# Safety Defect and Noncompliance Report Guide for Equipment PART 573 Defect and Noncompliance Report Form

### I. Identify the Recalled Items of Equipment

Make: Model Valor Stainless Exhaust Tips Part Number: 00016-48060 Size: N/A

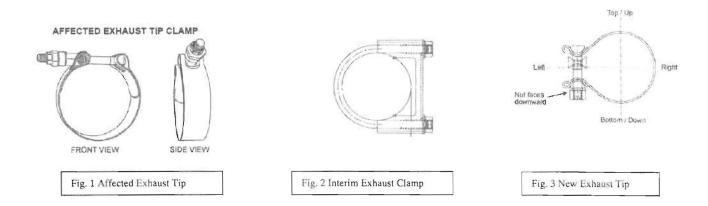
Due to improper heat treatment during the manufacturing process, the original clamp used to secure the Toyota Stainless Steel Exhaust Tip to the exhaust pipe may develop microscopic cracks. Eventually the crack may expand causing the clamp to break. In the worst case, the original clamp and the Toyota Stainless Steel Exhaust Tip may fall off the vehicle's exhaust pipe and become a road hazard.

The original clamp (Fig. 1) was replaced by an interim clamp (Fig. 2) on 9/12/08 and the Stainless Exhaust tip assembly part no was changed when the new improved clamp (Fig. 3) was added. On 10/28/08.

09/12/08	Replacement of original Exhaust pipe clamp with interim clamp (Fig. 2) in
	production.
10/28/08	Part no changed and New exhaust clamp is included in kit (Fig 3). Part number
	00016-48004.
11/25/08	TMS Advised to put stop sale on TMS exhaust tip.

Production remedy is the same as the recall remedy.
